ENROLLED ORDINANCE 173-028

MODIFY SPEED ZONE ON COUNTY TRUNK HIGHWAY V V

**TO:** Waukesha County Board of Supervisors  
**CC:** Allison Bussler, Gary Evans  
**FROM:** Bruce Barnes, P.E., PTOE  
**DATE:** June 18, 2018  
**SUBJECT:** Proposed reductions of posted speed limit along

# Adjust CTH VV-3 & Add CTH MD MD Speed Transition Zones

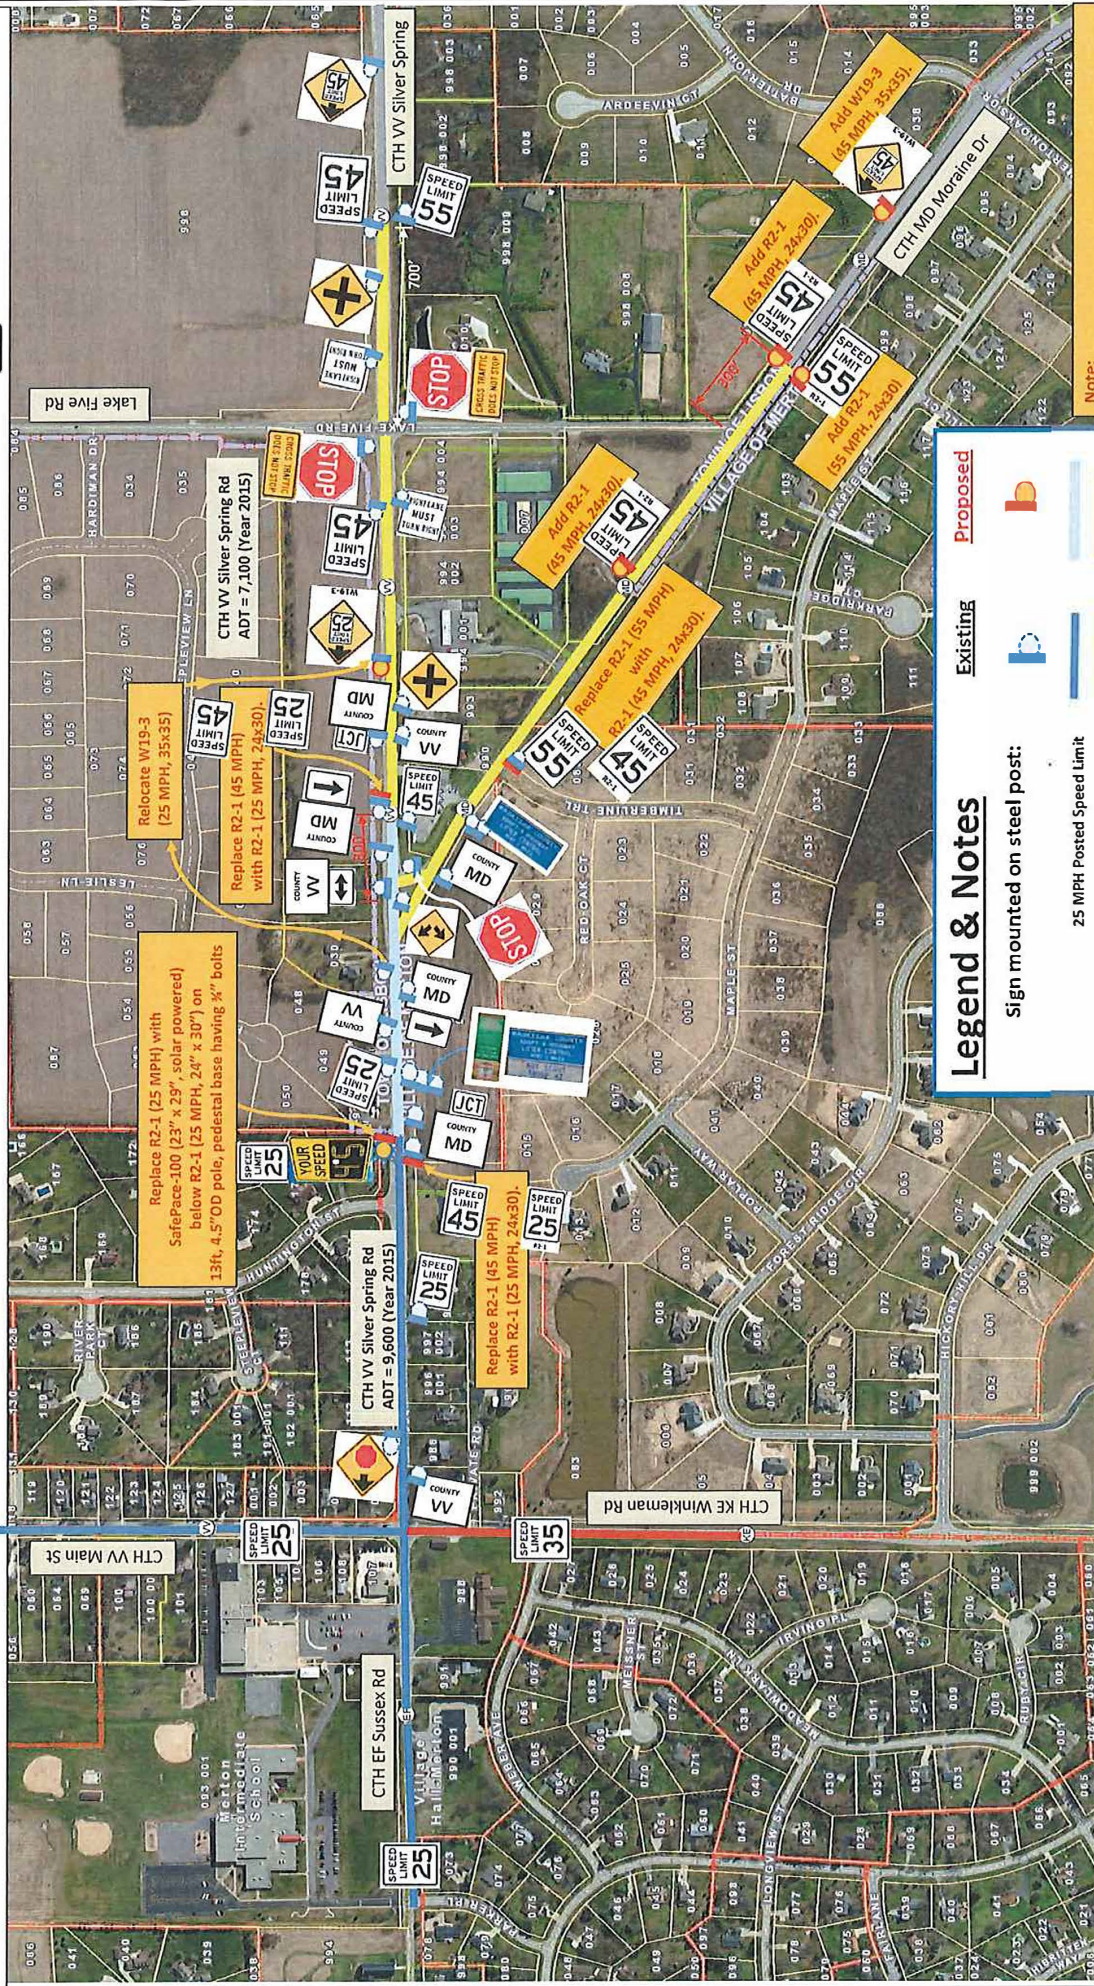
Replace R2-1 (25 MPH) with SafeSpace-100 (23" x 29", solar powered) below R2-1 (25 MPH, 24" x 30") on 13ft, 4.5"OD pole, pedestal base having "K" bolts

Relocate W19-3 (25 MPH, 35x35)

Replace R2-1 (45 MPH) with R2-1 (25 MPH, 24x30)

Replace R2-1 (45 MPH) with R2-1 (25 MPH, 24x30)

Add R2-1 (45 MPH, 24x30)

Replace R2-1 (45 MPH) with R2-1 (45 MPH, 24x30)

Add R2-1 (45 MPH, 24x30)

Add W19-3 (45 MPH, 35x35)

Add R2-1 (55 MPH, 24x30)

Add R2-1 (55 MPH, 24x30)
